**ROCKFORD BOARD OF EDUCATION  
INVITATION FOR BID ON SUPPLIES, MATERIALS, EQUIPMENT OR SERVICES  
FOR SCHOOL DISTRICT NO. 205  
ROCKFORD, ILLINOIS**

IFB No.        **17-40 Rockford Public School District 205 School B, Zone 1**

RE:        **ADDENDUM NO. 7**

Rockford Public School District 205  
School B, Zone 1  
Rockford, IL  
Cannon Project No. 005005.00

C16

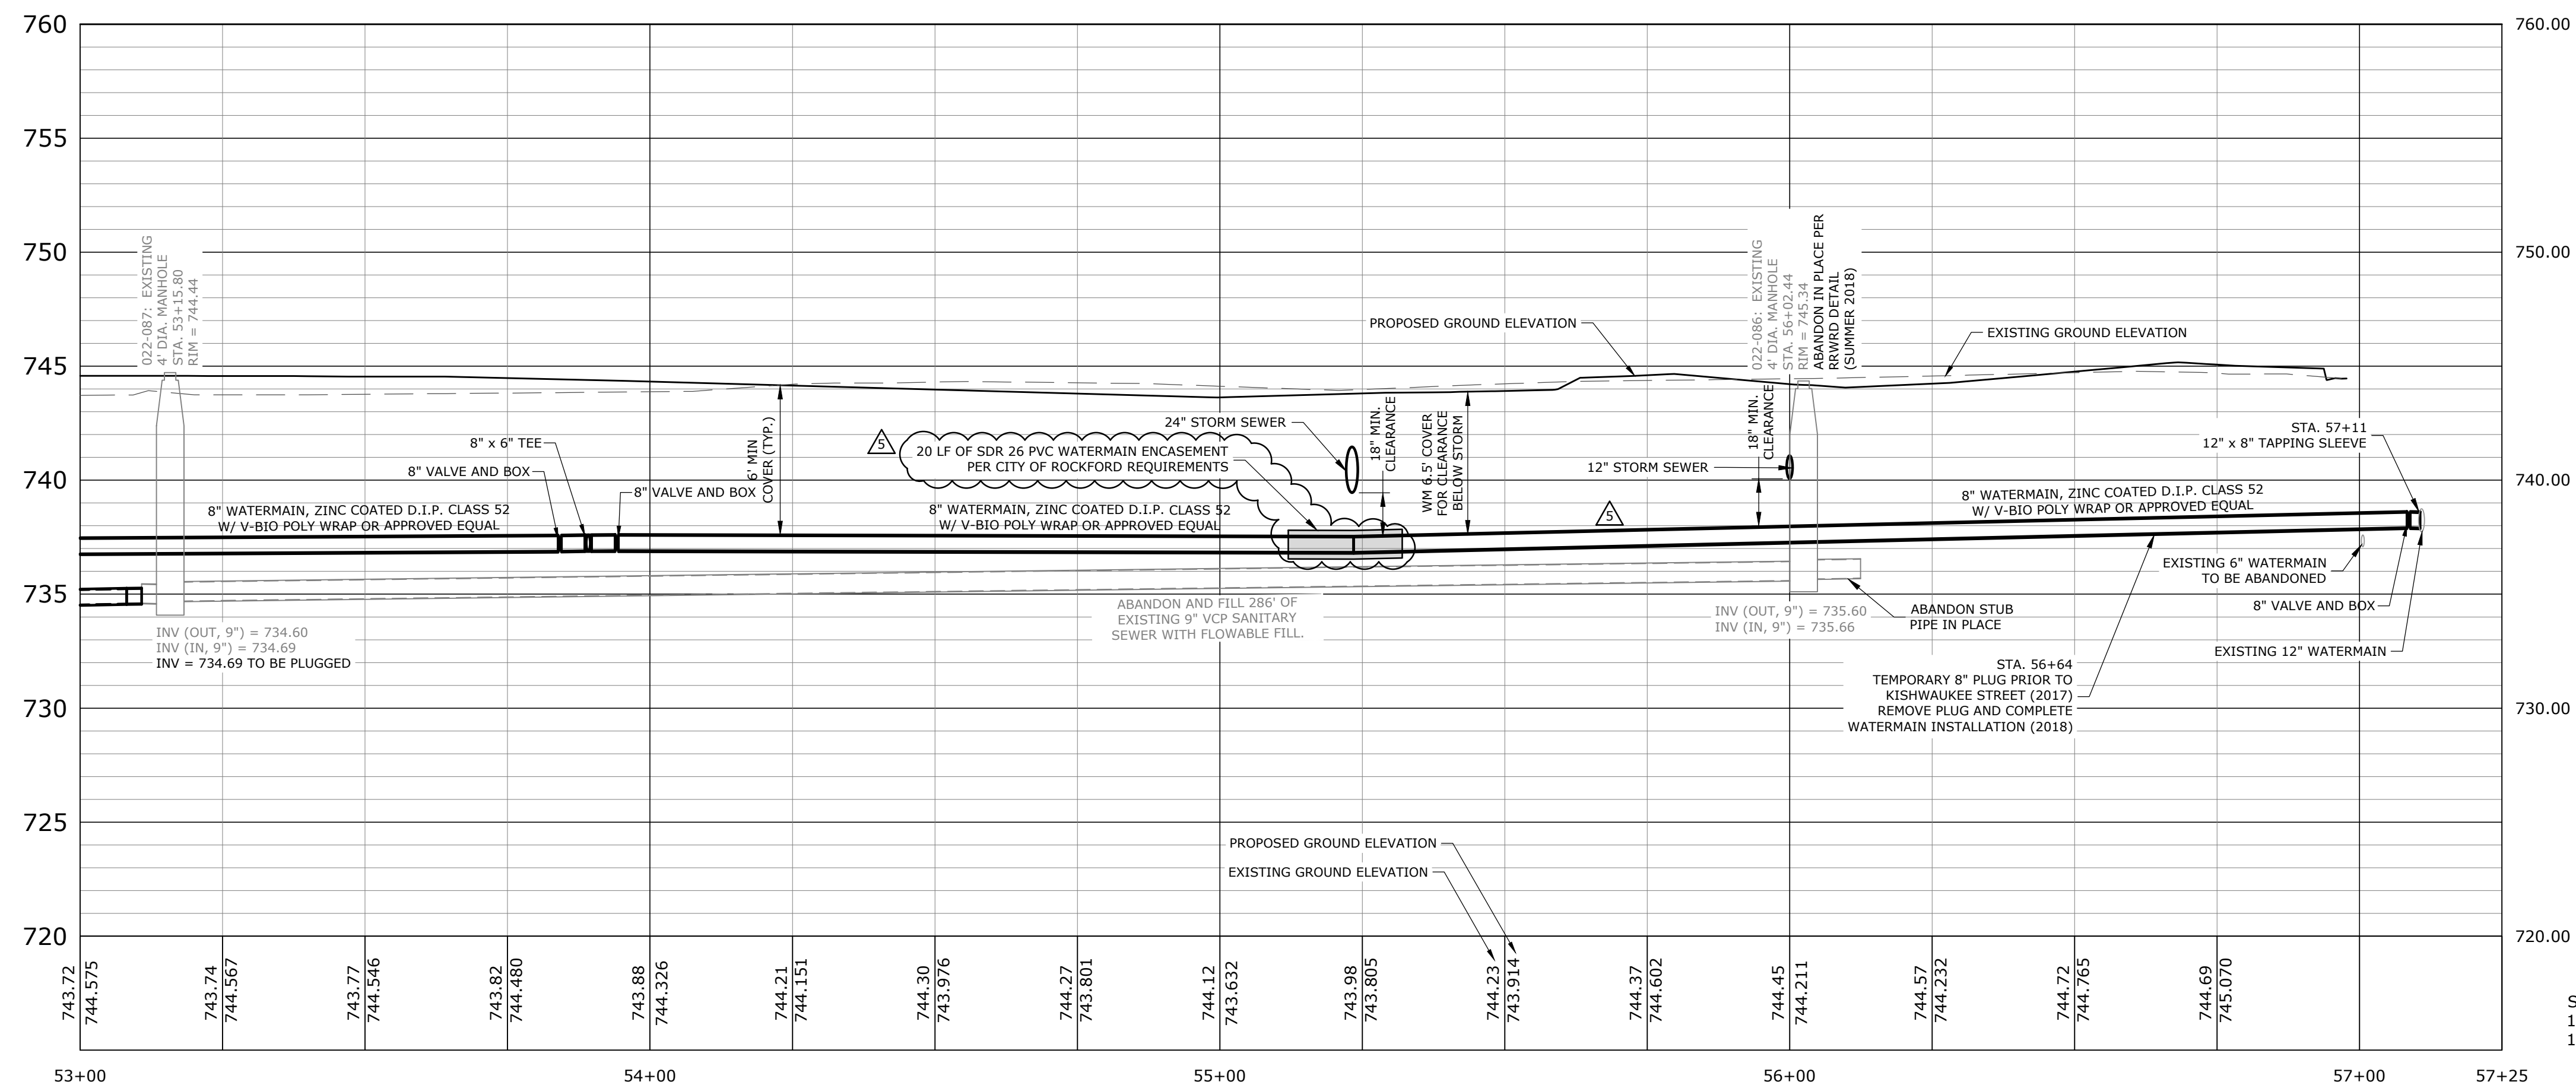
9. C16 – WATERMAIN AND SANITARY PLAN AND PROFILES STA. 50+00 - 54+00

- A. Added note regarding existing site utilities.

# C17

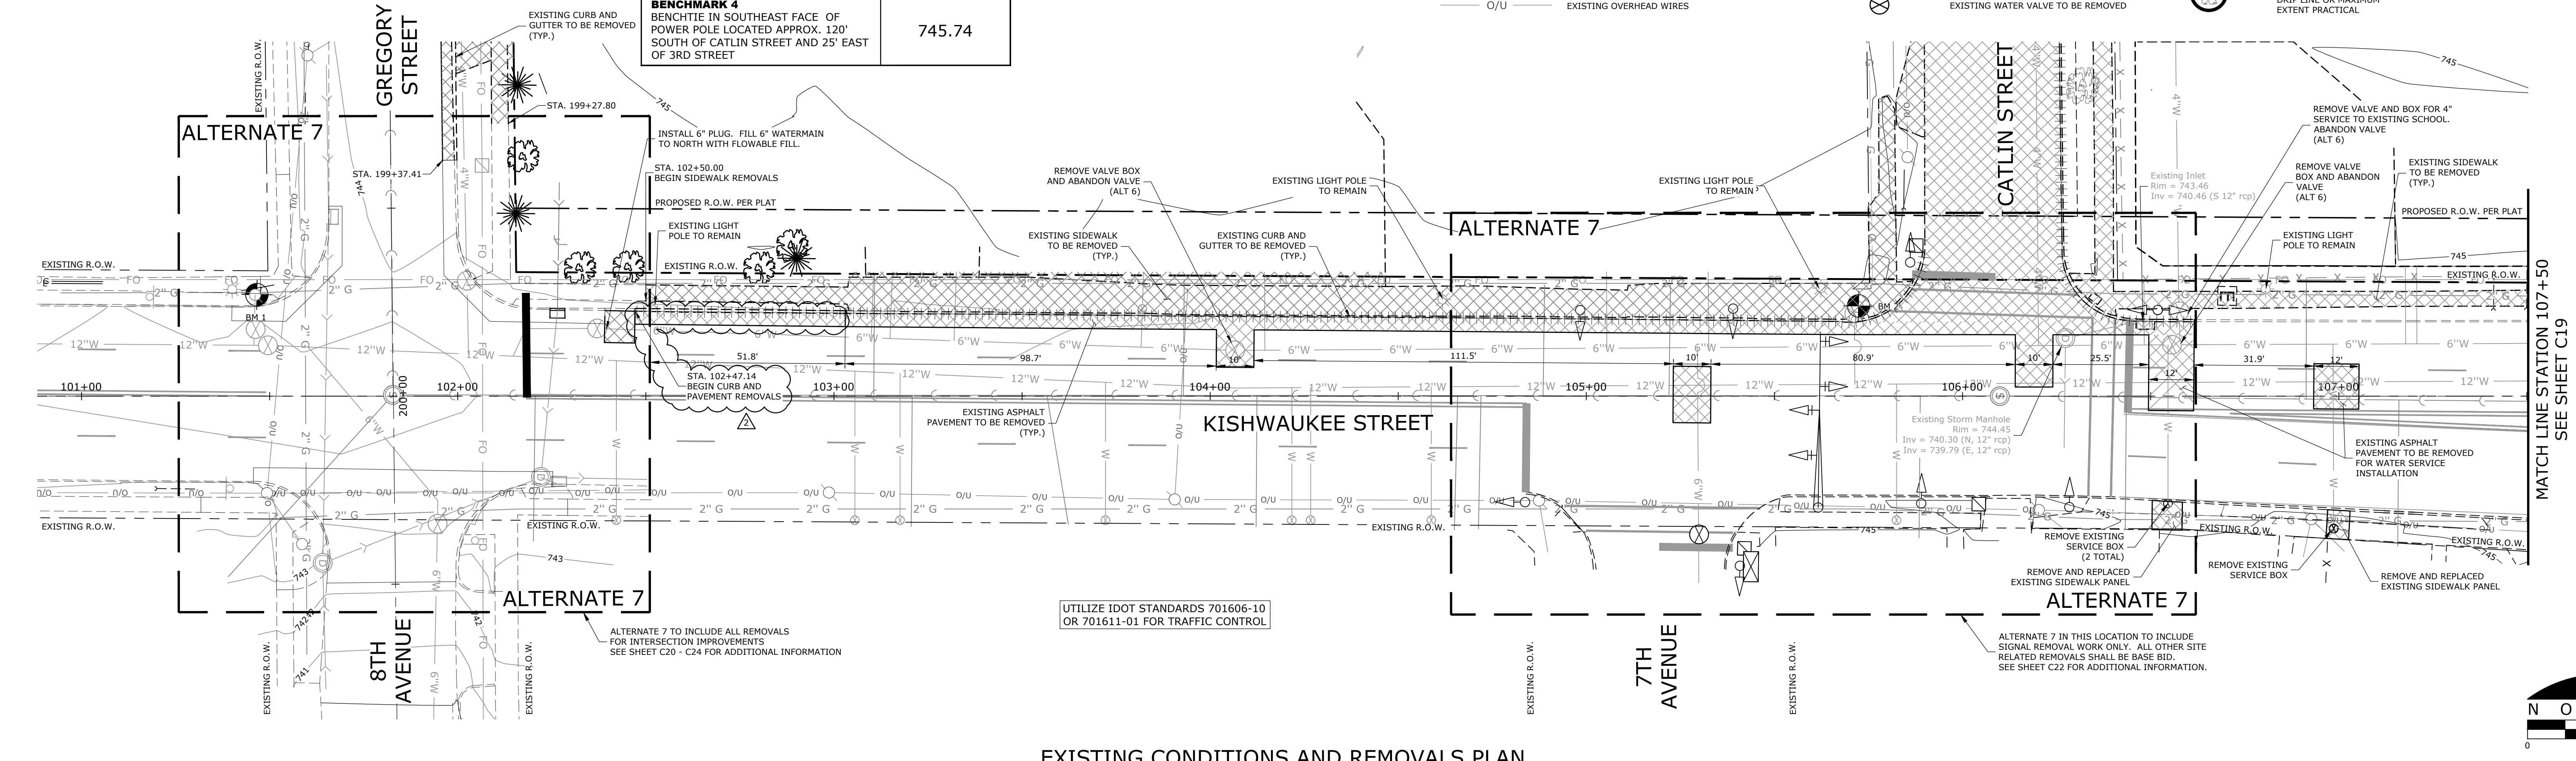
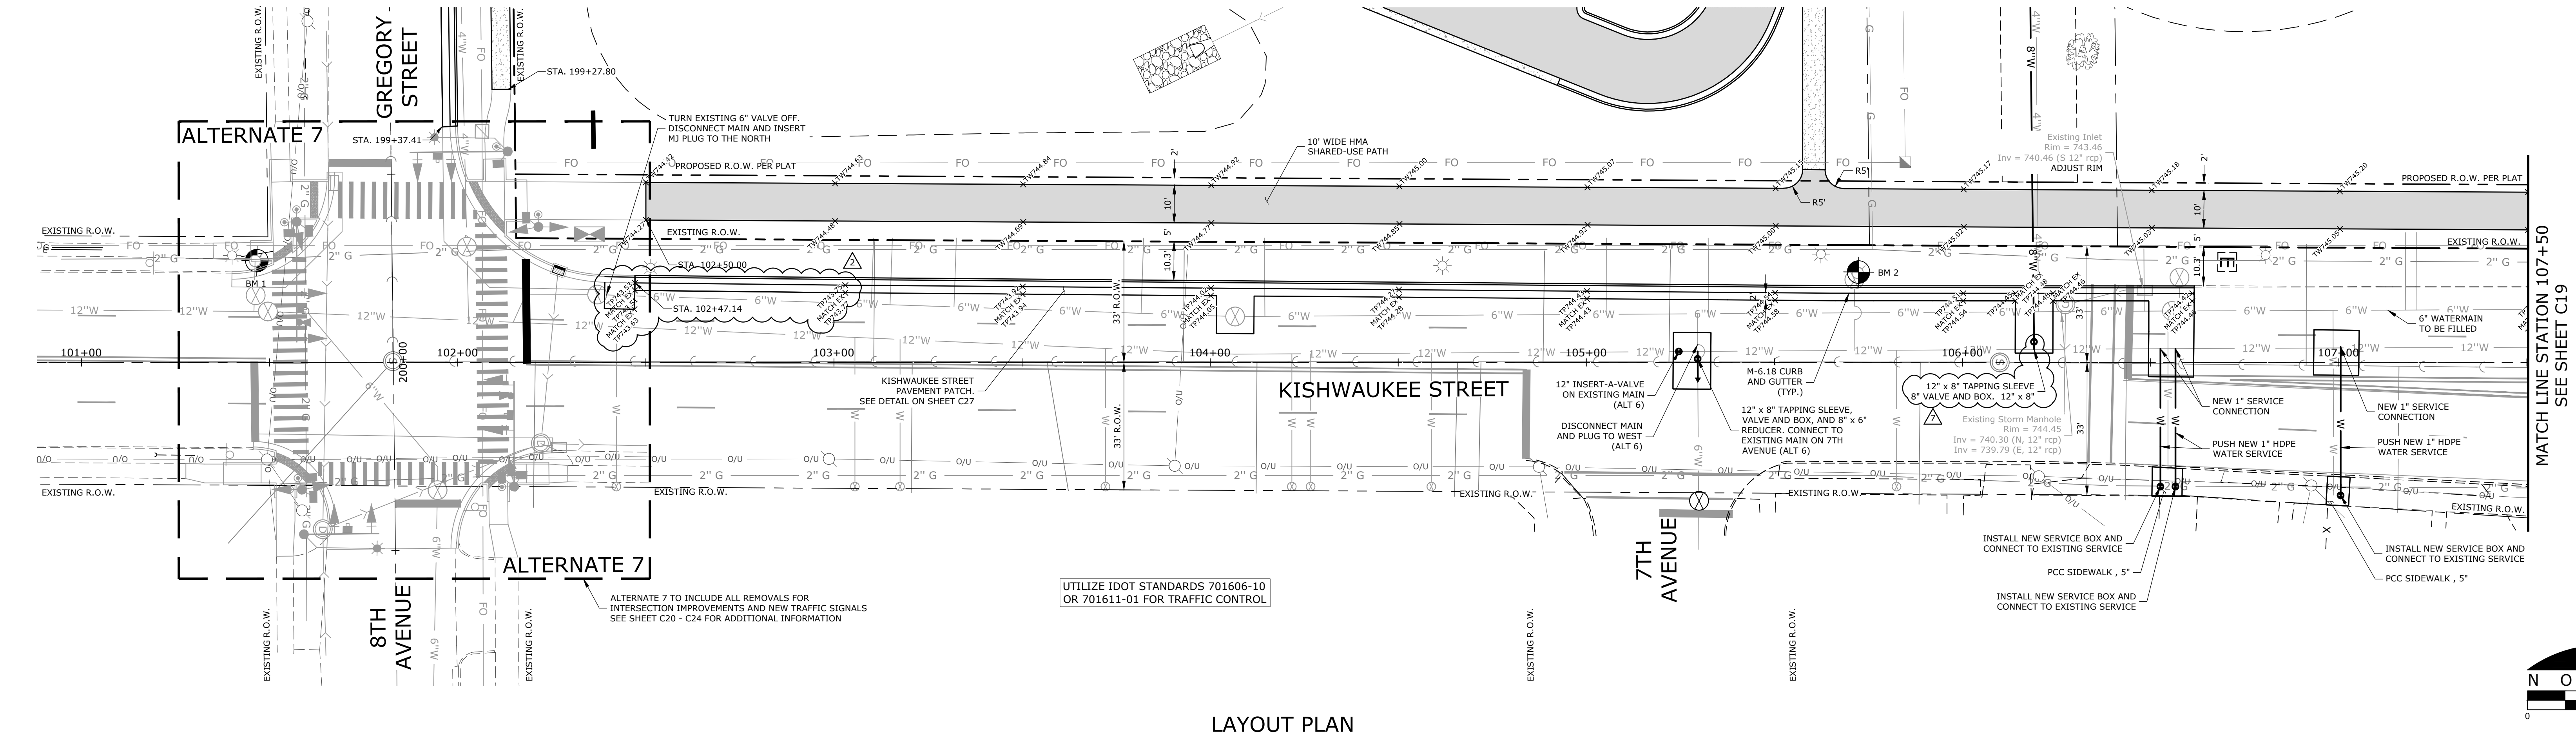
10. C17 – WATERMAIN AND SANITARY PLAN AND PROFILES STA. 54+00 - 57+25

- A. Added note regarding existing site utilities.

**ALTERNATE 6 WORK SCOPE:**  
ALTERNATE 6 INCLUDES THE WORK REQUIRED TO PROVIDE CERTAIN ENHANCEMENTS TO THE PROPOSED WATER SYSTEM IN ORDER TO MAKE THE SYSTEM MORE FUNCTIONAL ONCE COMPLETE AND TURNED OVER TO THE CITY OF ROCKFORD. SPECIFICALLY, THESE IMPROVEMENTS INCLUDE A NEW 8" VALVE AT THIRD STREET, NORTH OF CATLIN; DISCONNECT SEVENTH AVENUE MAIN FROM EXISTING SIX INCH MAIN AND CONNECT TO 12 INCH MAIN WITHIN KISHWAUKEE STREET; AND ABANDONING SIX INCH MAIN BY INSTALLING A PLUG AND FILLING THE LINE WITH FLOWABLE FILL PER IDOT REQUIREMENTS. ALTERNATE 6 ITEMS ARE SHOWN ON THE DRAWINGS.

**C18**

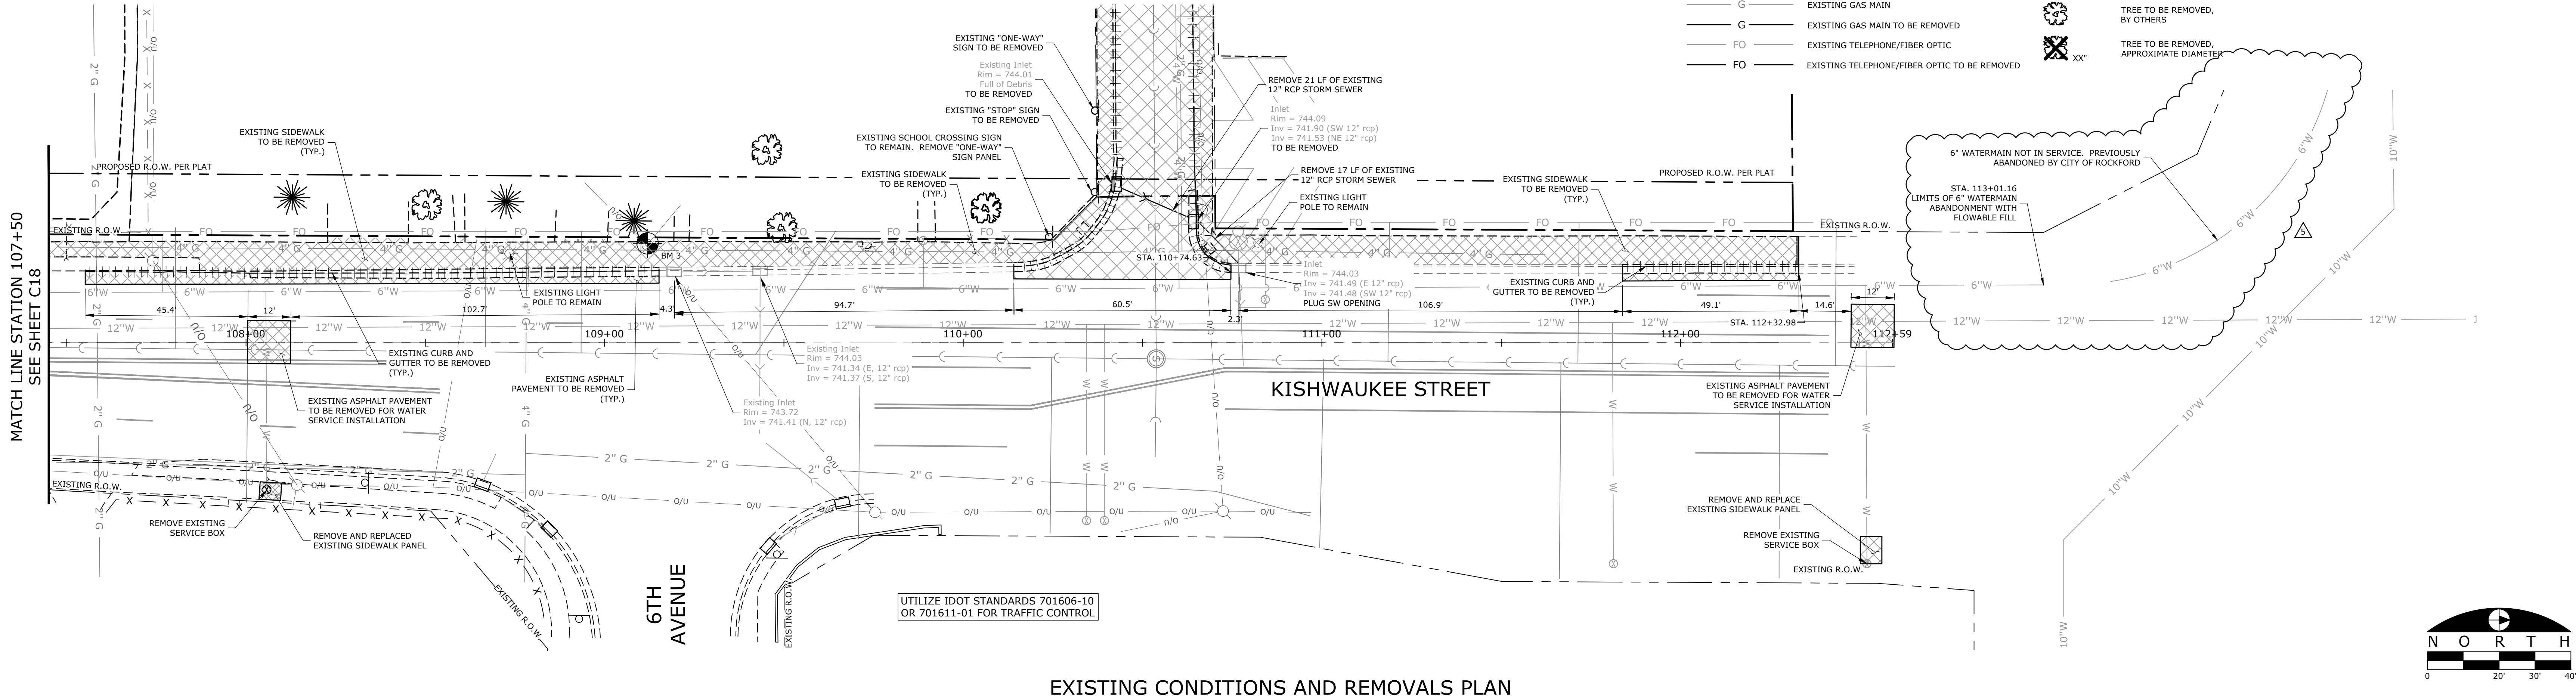
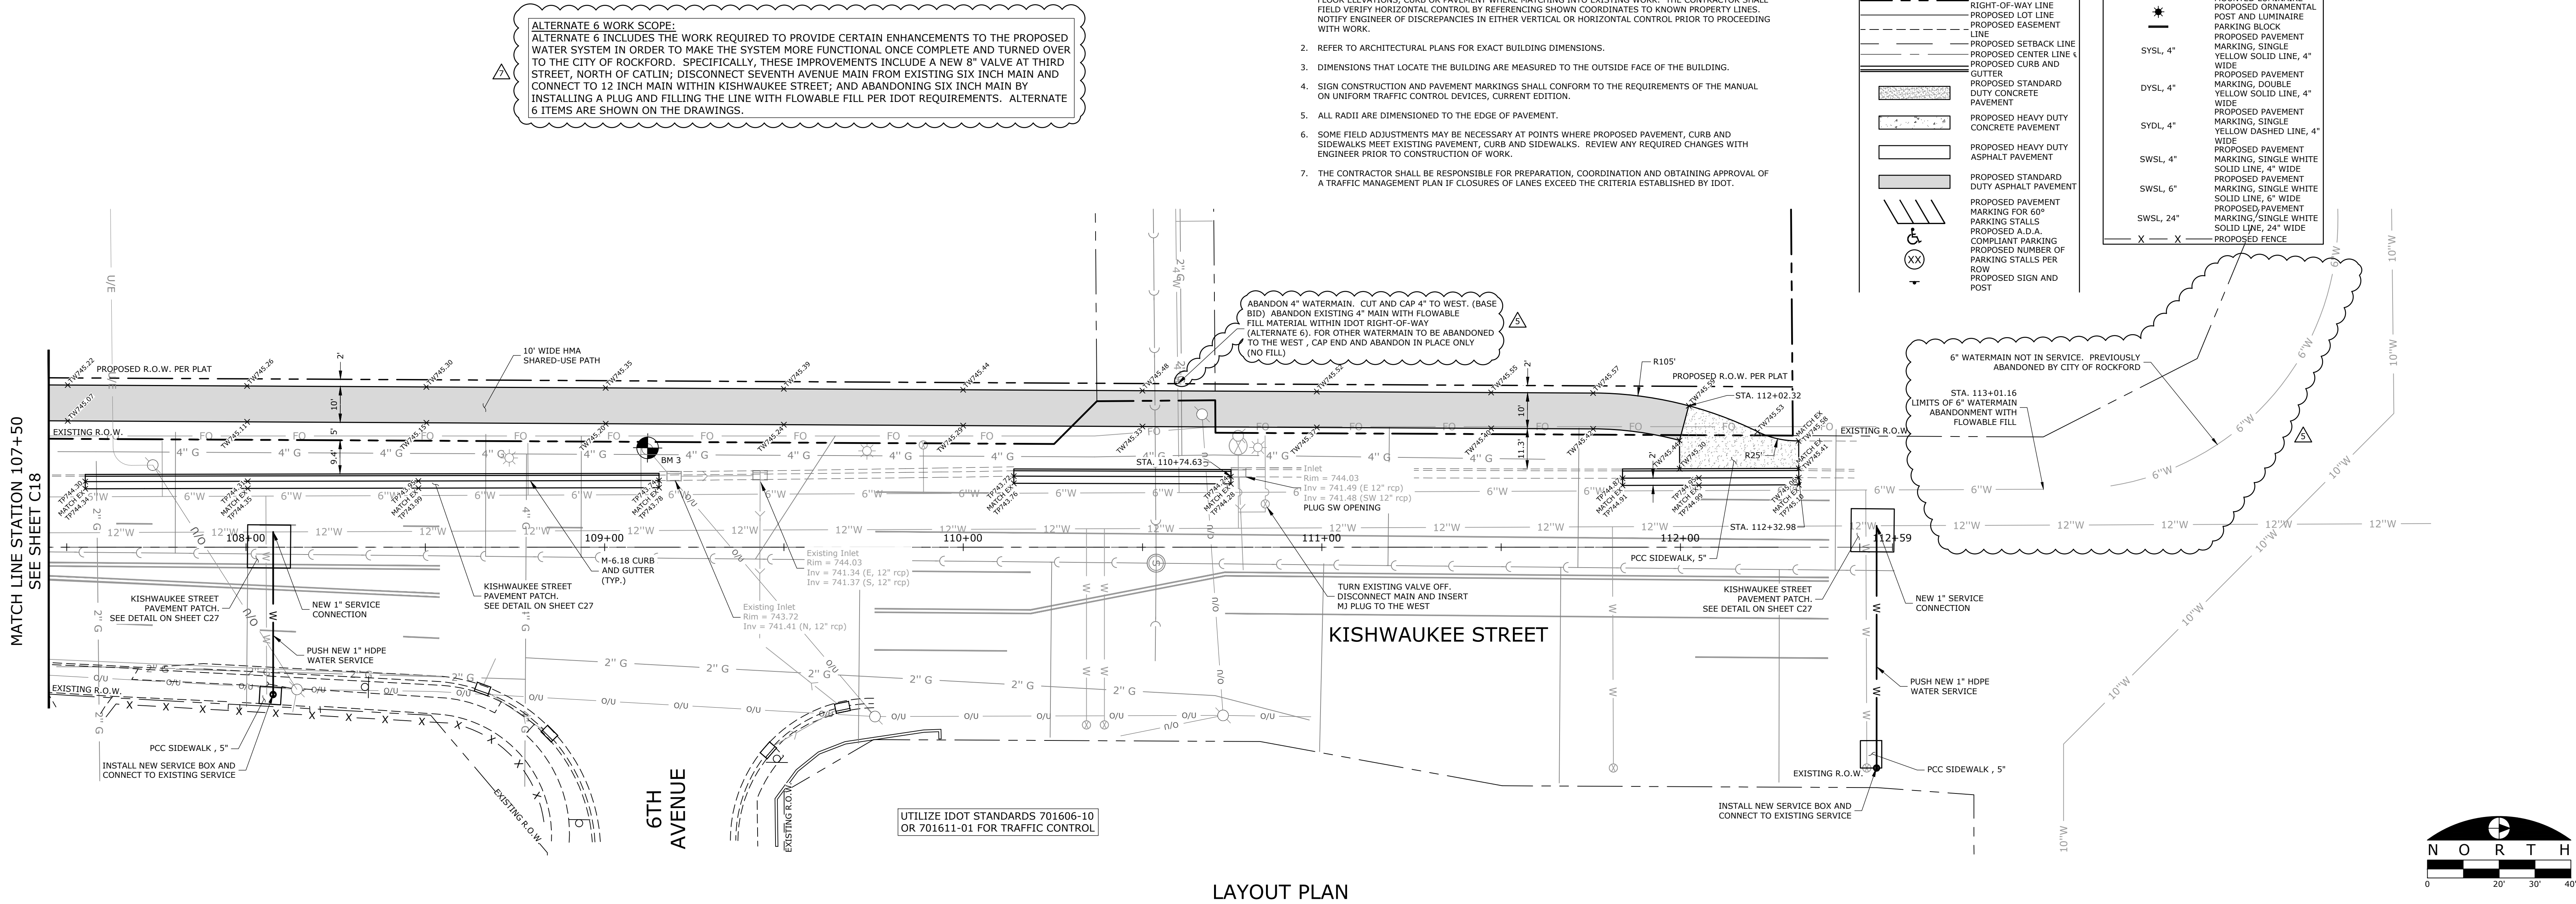
11. C18 – KISHWAUKEE STREET CORRIDOR PLAN STA. 101+00 - 107+50
  - A. Added description of alternate 6 work.
  - B. Revised notes to eliminate reference to dates.
12. C19 – KISHWAUKEE STREET CORRIDOR PLAN STA. 107+50 - 112+50
  - A. Added description of alternate 6 work.

**ALTERNATE 6 WORK SCOPE:**  
ALTERNATE 6 INCLUDES THE WORK REQUIRED TO PROVIDE CERTAIN ENHANCEMENTS TO THE PROPOSED WATER SYSTEM IN ORDER TO MAKE THE SYSTEM MORE FUNCTIONAL ONCE COMPLETE AND TURNED OVER TO THE CITY OF ROCKFORD. SPECIFICALLY, THESE IMPROVEMENTS INCLUDE A NEW 8" VALVE AT THIRD STREET, NORTH OF CATLIN; DISCONNECT SEVENTH AVENUE MAIN FROM EXISTING SIX INCH MAIN AND CONNECT TO 12 INCH MAIN WITHIN KISHWAUKEE STREET; AND ABANDONING SIX INCH MAIN BY INSTALLING A PLUG AND FILLING THE LINE WITH FLOWABLE FILL PER IDOT REQUIREMENTS. ALTERNATE 6 ITEMS ARE SHOWN ON THE DRAWINGS.
